## CIVA Glider Aerobatics Committee, GAC, Report 2022

### Agenda Item 8.3

The GAC met at Issoudun France on August 16 at 15.00.

## §1.4 Figures in unlimited Unknowns

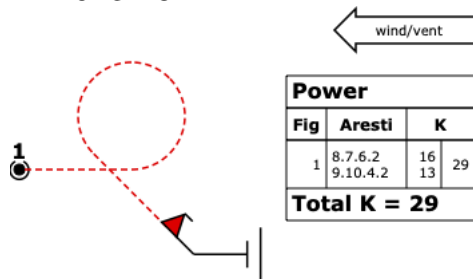
To preserve our old aircraft FRA recommends us to eliminate flick rolls on 45 degrees down lines after a looping segment in order to avoid flick rolls performed at too high speed.

GAC recommends the Plenary to **accept** this proposal.
